MAJOR PROJECT ASSESSMENT:

***Concept Plan for a Residential Mixed Use
Development***

71-79 Macquarie Street, Sydney

Director-General's
Environmental Assessment Report
Section 75I of the
Environmental Planning and Assessment Act 1979
September 2012

Figure 7 – Contextual elevation showing the height transition to city buildings (Source: Proponent's Design Report)

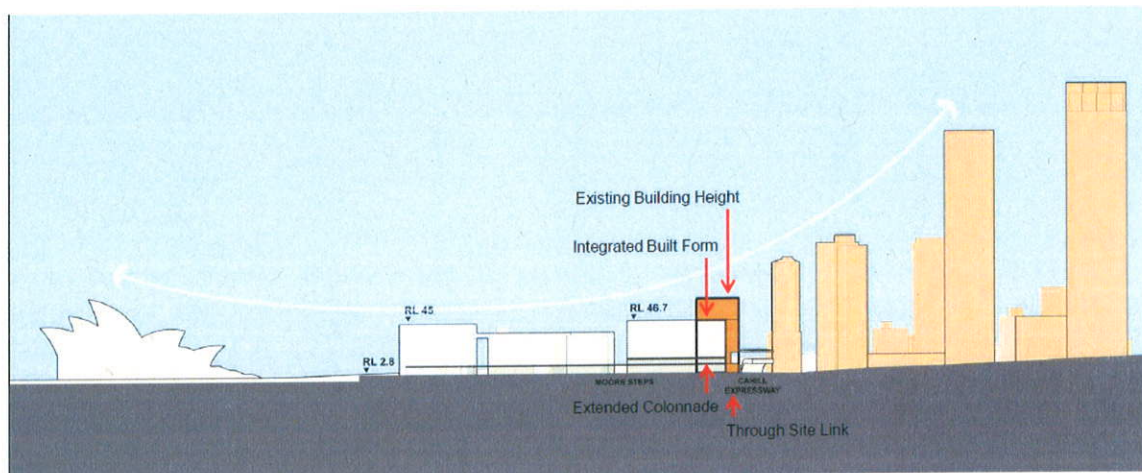
The adjoining Quay Grand to the north is approximately 20m lower than the existing building on the site. The Quay Apartment building, adjoining the southern side of the Cahill Expressway, is approximately 33m higher than the existing building on the site (with taller buildings further to the south). From this it can be seen that the height of the proposed building envelope will retain a stepped down building form from the higher city buildings to the south to ensure a gradual transition to the relatively low scale Quay Grand and Bennelong Apartments to the north (**Figures 7 and 8**).

The department therefore considers that the stepped building transition will result in a good design outcome by minimising the otherwise abrupt change of scale to the city buildings.

Figure 12 – Existing view from the northeastern Quay Apartment at RL 46.7m (Source: Proponent's Visual Analysis)

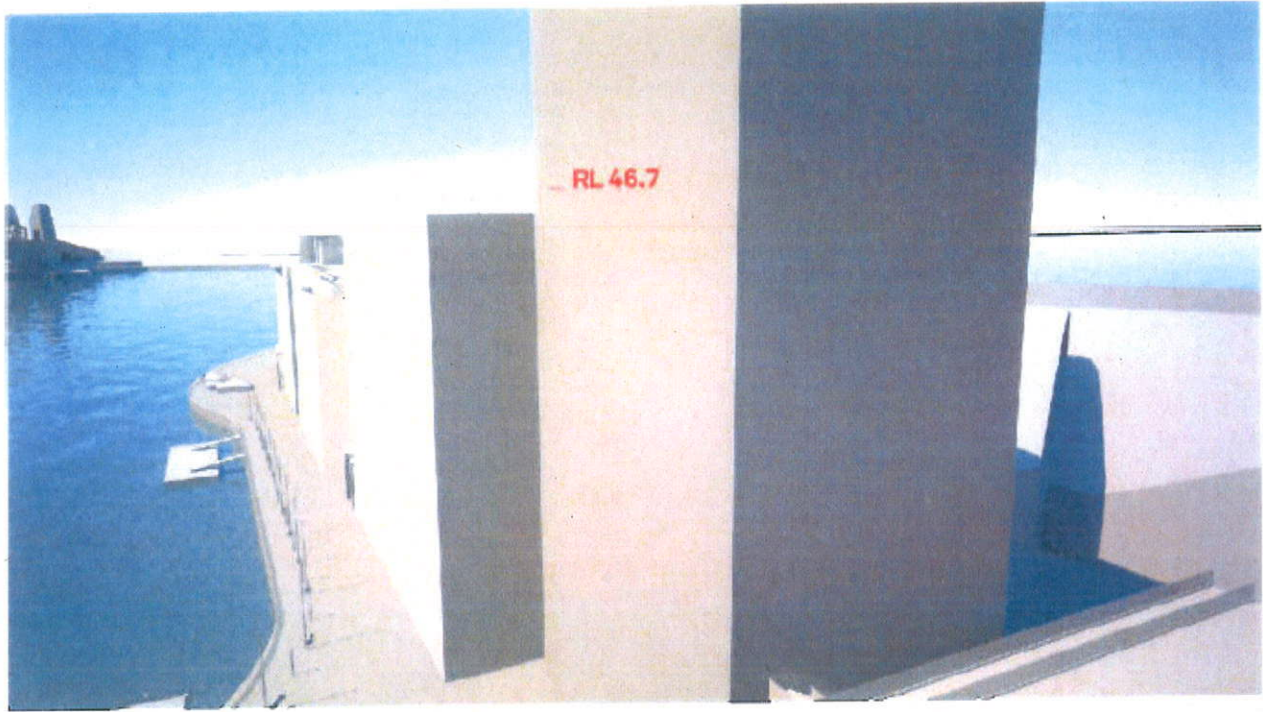
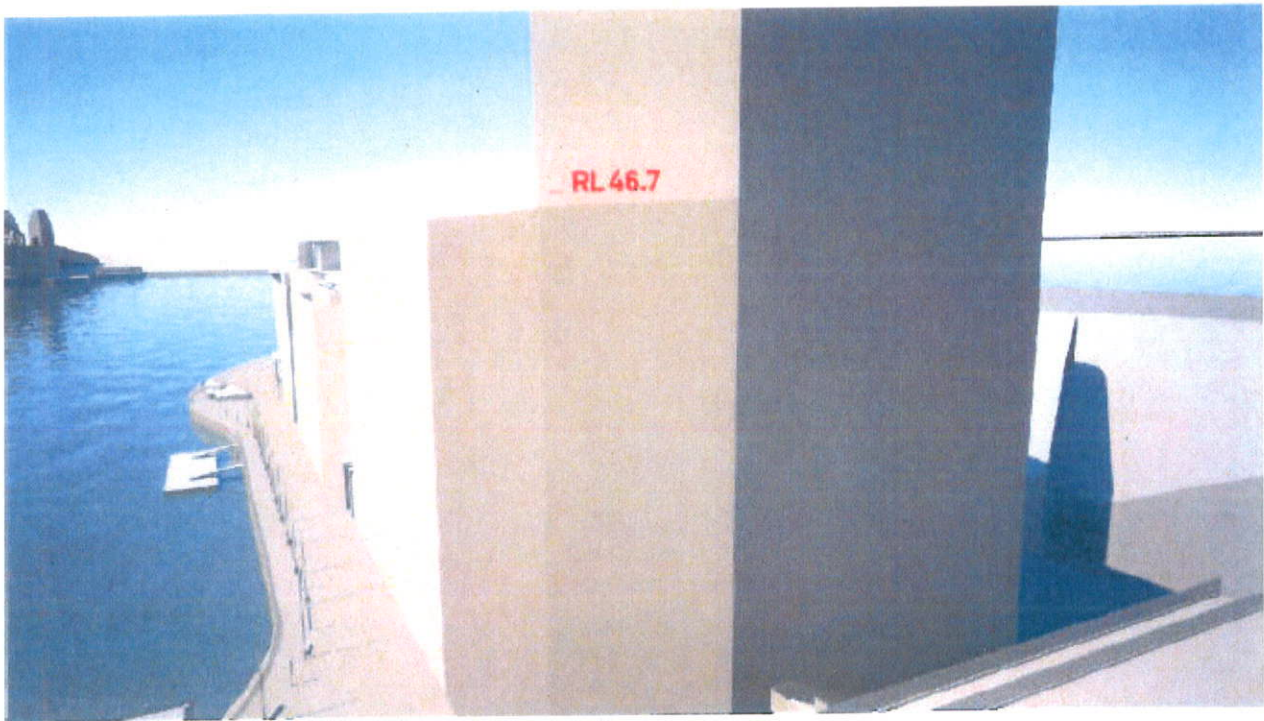
The department considers that the potential view impacts from the height of the building envelope are relevant from the Quay Apartments which have two dwellings per floor comprising a northwestern and northeastern apartment with northerly aspects.

The worst case scenario is from the northeastern apartments and the proponent's view analysis shows that the proposed building envelope will obstruct views of an area of northern sky at the middle level (RL 46.7m) of the Quay Apartments. However, extensive views including Sydney Harbour Bridge, The Rocks, Circular Quay and Farm Cove to the east would be retained. The department therefore considers the view loss in the context of views retained for these affected apartments is minor (refer to **Figures 12** and **13**).

Figure 14 – Existing view from a northeastern apartment at the Quay Apartments at RL67m
(Source: Proponent's Visual Analysis)

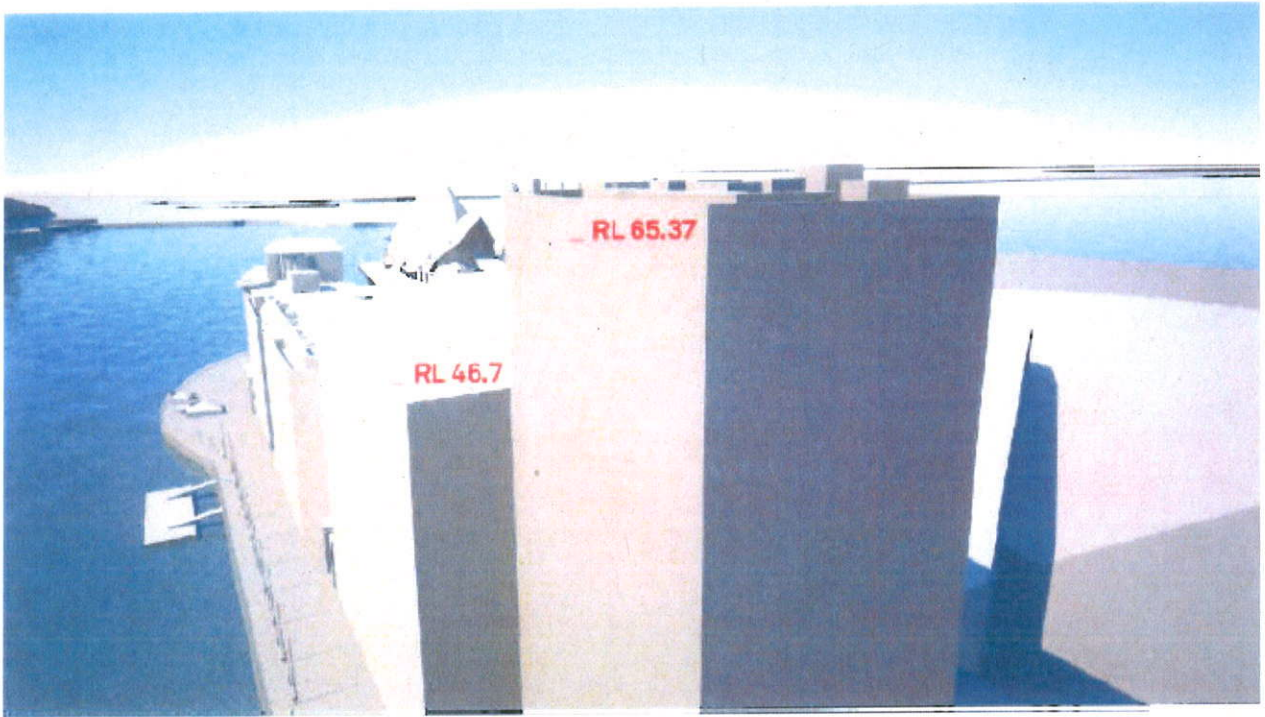
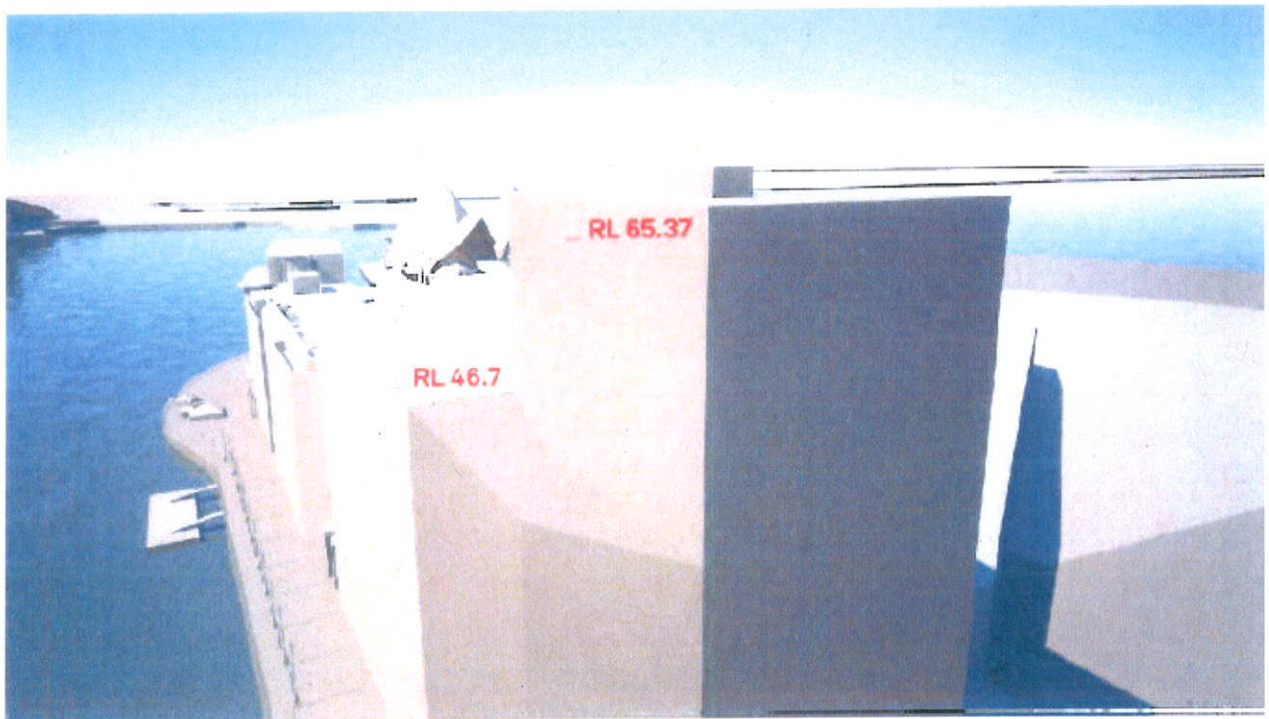
The view analysis also indicates that the proposed building envelope would obstruct part of the northern view, including the eastern sail of the Sydney Opera House at RL 67m (refer to **Figures 14 and 15**). However, the department considers the view impact is not unreasonable in the context of the extensive views retained, including Sydney Harbour Bridge, The Rocks, Circular Quay and Farm Cove. In any event the view impact is existing and there will be no additional view impact as a result of the proposed building height envelope.

Figure 16 – View Impact from top floor of the Sir Stamford Hotel southeast of the site (Source: Proponent's Design Report)

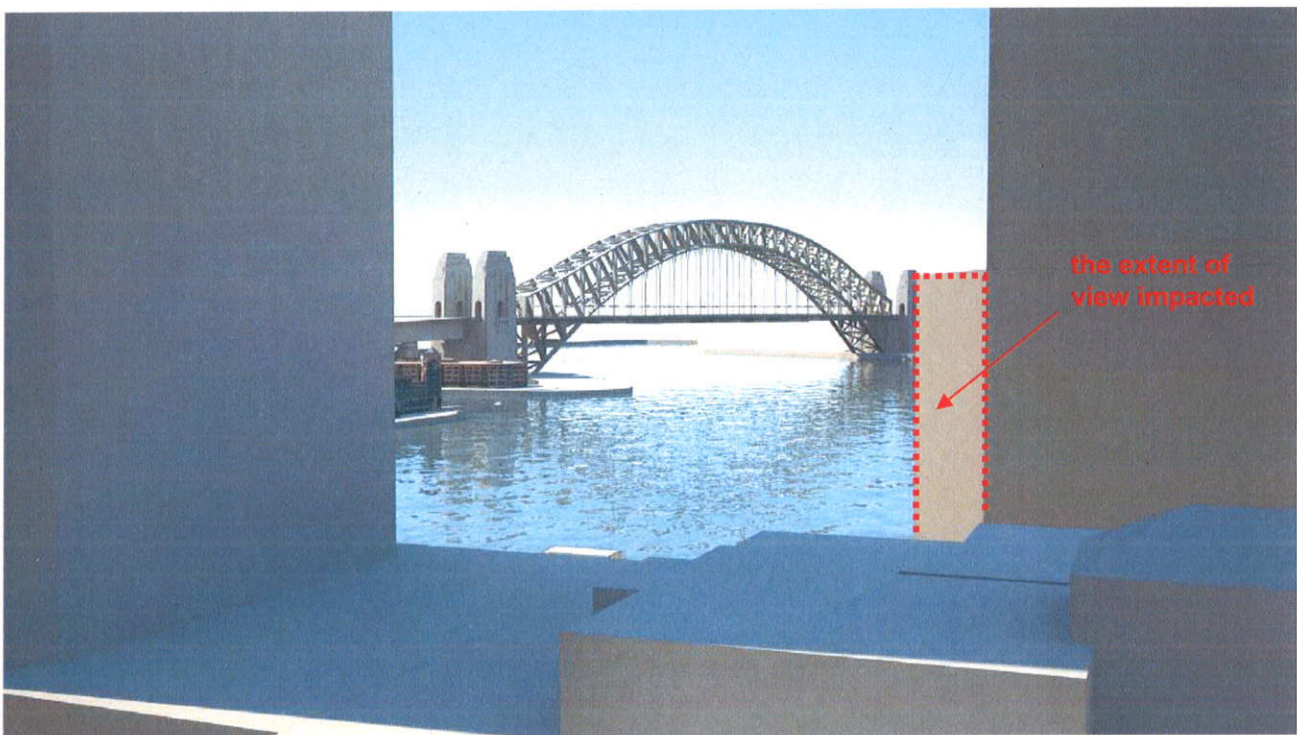
However, the proponent's view analysis shows the northeast pylon of the Sydney Harbour Bridge will be obscured when viewed from easterly windows of two rooms at the top floor of the Sir Stamford Hotel due to the western extension of the building envelope (**Figure 16**). A chamfer is provided to the southeastern corner of the proposed building envelope to minimise the view impact from the Sir Stamford Hotel. The department considers the view impact from the Sir Stamford Hotel is minor and acceptable when considered in the context of the view retained and the views available from other windows.

Figure 17 – View to the south from an apartment balcony at the Quay Grand. The red dashed line indicates the extent of view that potentially will be removed due to the western extension of the proposed building envelope (Source: Department's site photo)

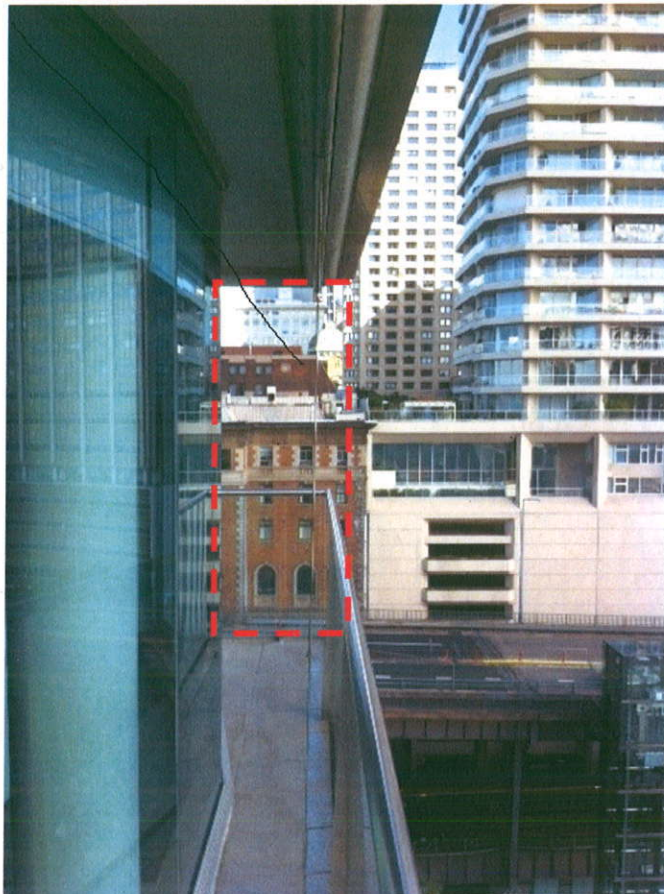
Concerns were also raised by residents at the Quay Grand due to the potential loss of views to the south arising from the western extension of the proposed building envelope. The existing views to the south of the city buildings from the indoor pool area and the southernmost apartment balconies will potentially be affected by the western extension of the building (refer to **Figure 17**). The department considers that the view loss to the south is minor when considered in the context of the views retained to the west of The Rocks, the Overseas Passenger Terminal and Sydney Harbour Bridge (refer to **Figure 18**).

Figure 19 – Proposed Access Arrangements (Source: Proponent's Traffic Report)

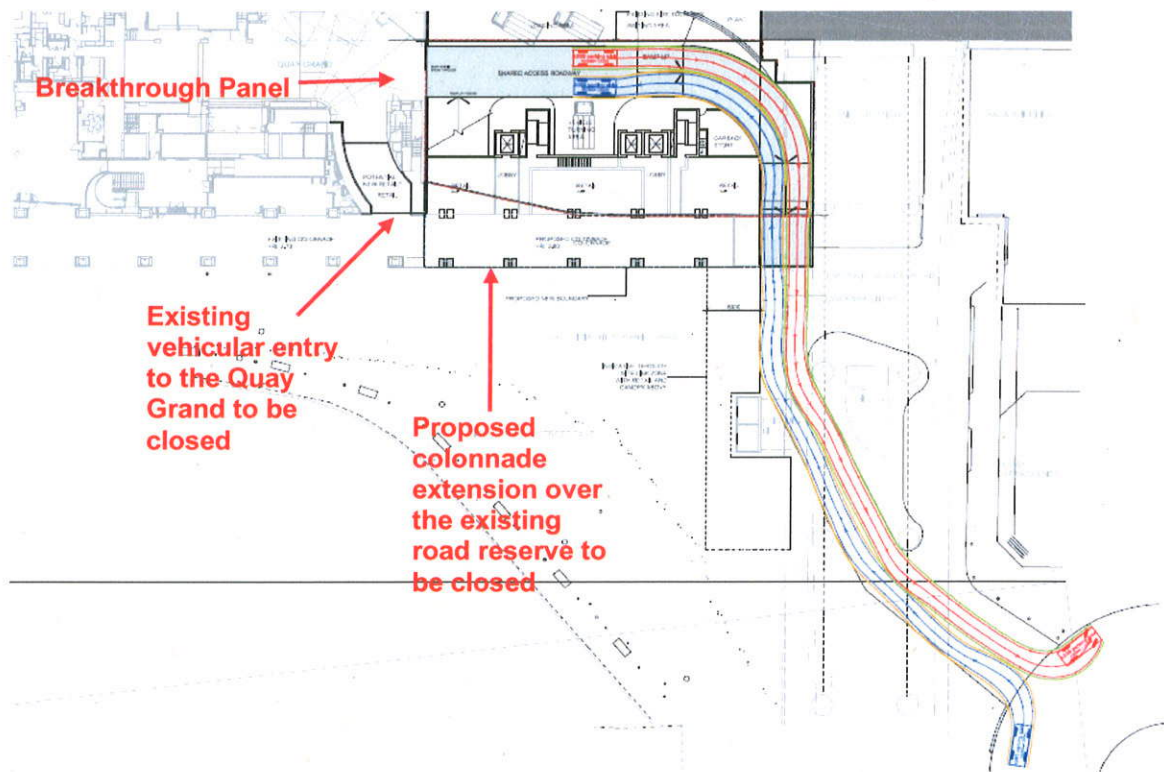
A number of issues have been raised by the Quay Grand residents in relation to whether the site can adequately accommodate the vehicular access and servicing needs of both buildings. The specific issues raised include the width of the access driveway, queuing times and the inadequate turning areas for trucks in the basement.

The proposed combined driveway to serve the Quay Grand and the subject development will be located in approximately the same location as the existing driveway serving the subject site. The internal basement driveway is proposed to be 5.5m wide which is wide enough to allow two cars to pass. However, based on the current indicative design layout the curved section of the driveway is not wide enough to allow a car and truck to pass each other at the same time.

The department considers the vehicular access arrangements for future development on the site should provide for a truck and a car to pass each other without unnecessary delays for future users.

In this regard the department does not support the proposed 5.5m width and a modification to the ground level layout demonstrating compliance with AS2890 is included in the recommended instrument of approval.

Figure 20 – Indicative Building Interface with the Quay Grand Building (Source: Proponent's RtS)

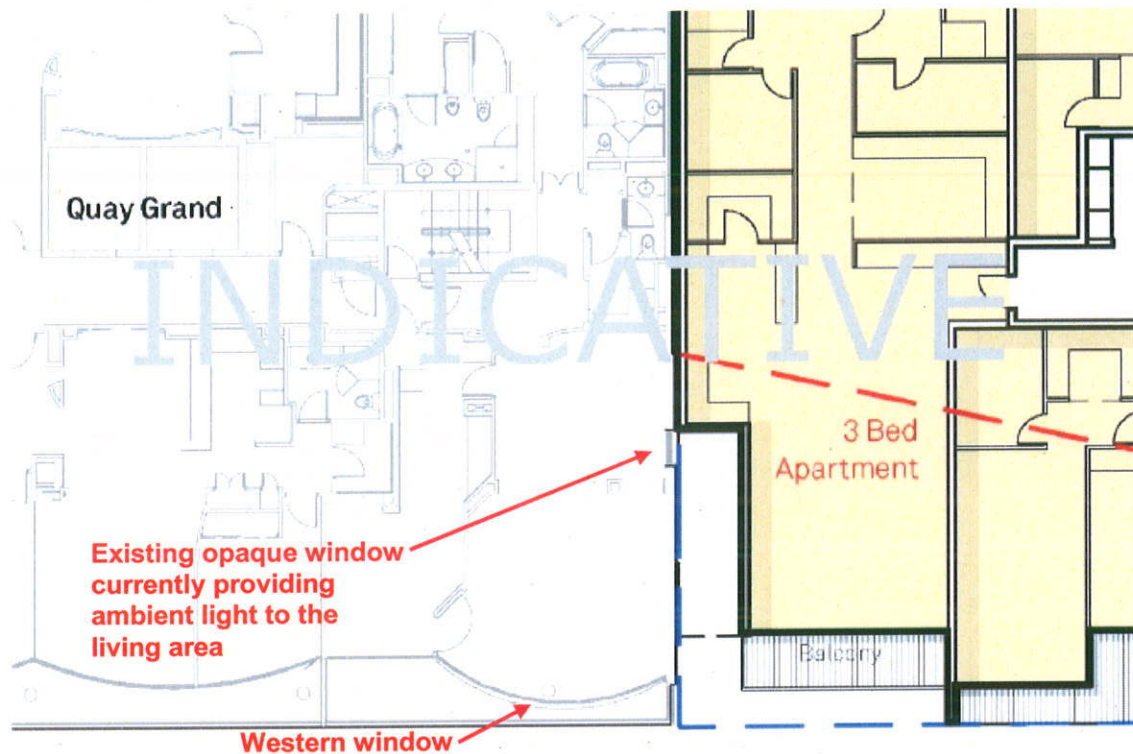
The lower portion of the building envelope (below the level of the Quay Grand building roof) is proposed to extend further west to align with the western façade of the Quay Grand Building. This western extension will also abut the common boundary with the Quay Grand. The southern elevation of the Quay Grand has opaque windows which provide indirect ambient daylight to the adjoining living/dining room in seven apartments. The proponent is seeking approval for a building envelope and the future development will potentially affect ambient daylight provided by these windows. The department notes that the proposal will not have any impact on the direct sunlight received by the western windows in these apartments. The proponent has submitted an indicative design solution with a building recess/light well which would assist in retaining ambient daylight to the potentially affected windows (**Figure 20**). From the information provided the department accepts that the impact of the future development on these windows can be appropriately addressed at the future detailed design stage.

Concern has also been raised by the Quay Grand residents in relation to the potential impact on the amenity of the internal pool area (located at level 2) which has a large curved double height window overlooking Circular Quay. The Quay Grand residents are concerned the indoor pool area will be affected in regards to sunlight access. The department does not accept there will be reduced solar access to the pool area given the subject site is located to the south of the Quay Grand.
